STATE OF WASHINGTON  
DEPARTMENT OF ECOLOGY

**Re: Subsurface Work at the Hamilton Street Bridge Site in Conjunction with the Phase 2B Martin Luther King Jr. Drive and Ben Burr Trail Construction**

Attachments: Phase 2B MLK Jr. Drive, preliminary stormwater conveyance system and Ben Burr trail alignment, dated Jan 2018

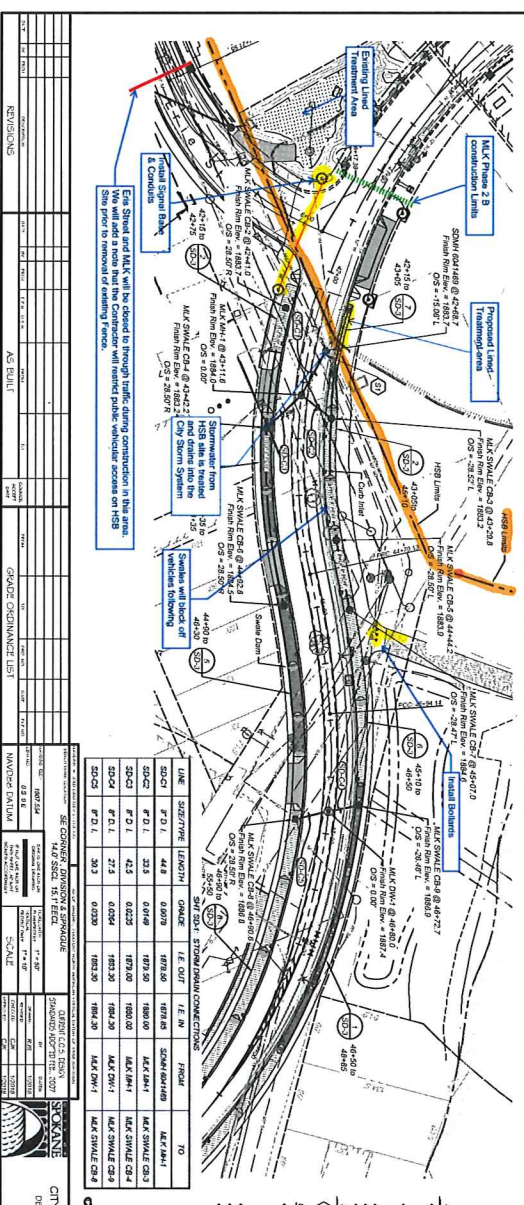
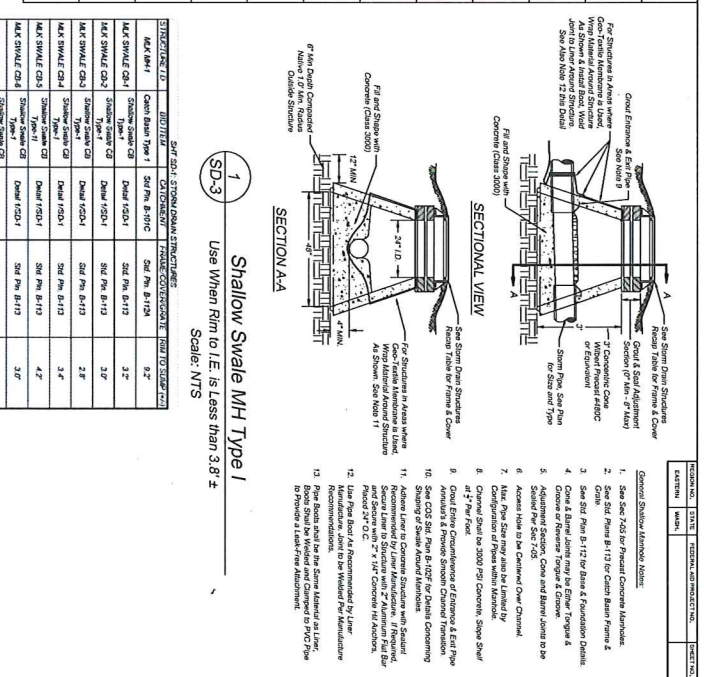
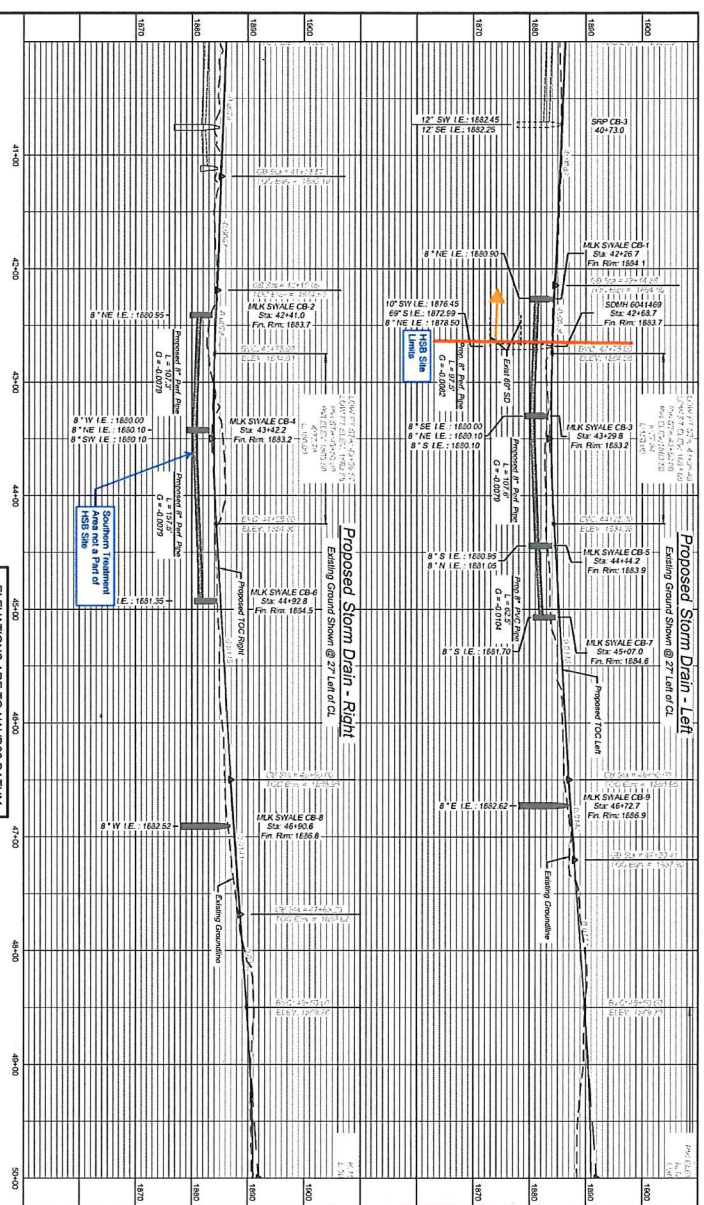
1. Ecology's concurrence of the MLK stormwater plans and the Ben Burr trail alignment is based upon the preliminary drawings of the Phase 2B that are showing the MLK Jr. Drive stormwater conveyance structures and the planned alignment of the Ben Burr trail. The drawings are dated January, 2018, sealed by Cindy Kinzer, P.E. and enclosed with this letter.

2. The storm basin delineations, stormwater facility location, type and sizes and the Ben Burr trail alignment were identified in these preliminary drawings. It is also Ecology's understanding that no subsurface work is associated with the construction of the Ben Burr trail. Hence, if any Phase 2B subsurface work or the Riverside trail alignment deviate from the attached drawings within the Site footprint, as well as any other groundwater monitoring wells are to be modified, the City will inform Ecology of any changes or deviations within one week. Additionally, the City will notify Ecology of any planned modifications of other groundwater monitoring wells, beyond those wells identified in the attached drawings, before any well modifications are performed.

5. If contaminated soils and groundwater are encountered outside the Site footprint as shown in the attached drawing, the City must contact Ecology within a maximum of 90 days from discovery. However, to expedite the construction of Phase 2B as smoothly as possible, Ecology recommends that any discovery of contaminated soils and groundwater outside the Site footprint be reported to Ecology as soon as possible.

7. The City must provide Ecology with a report summarizing all materials disposed of from the Site with field observations, chemical analysis, final disposition of the waste, and waste manifests from excavations performed within the Site footprint as shown in the attached MLK Drive Phase 2B storm conveyance system drawings. The report shall also include a description and certification of any fill material brought into the site showing the origin and that the fill conform to the requirements set forth in item No. 7 above.

11. The project specifications provide the Contractor with Landau's contact number to coordinate well monitoring schedules.
12. Five of the monitoring wells need to be adjusted with this project. The standard monitoring well detail sheets and covers must be a part of the Contract bid documents. A copy of the specifications and details were presented at the meeting and found acceptable. Modifications to the groundwater monitoring wells must be performed by a State of Washington licensed well drilling contractor. The affected wells are identified in the attached Site drawing.
